Office Action Summary

10/529,515

SU ET AL.

DETAILED ACTION

Figure 2

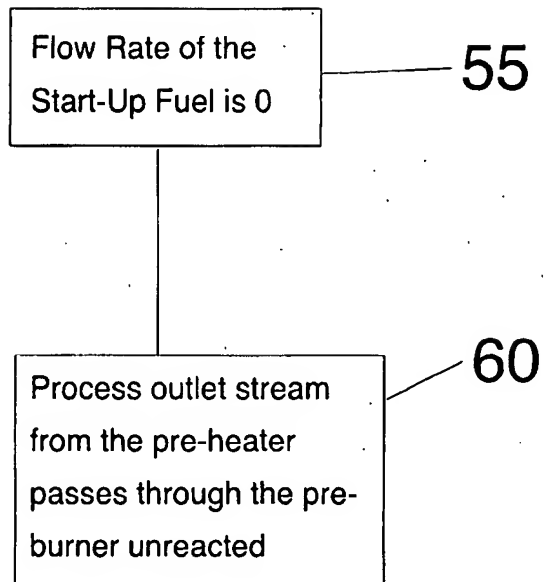
3. Entry of New Fig. 2 is approved.

Entry Approved
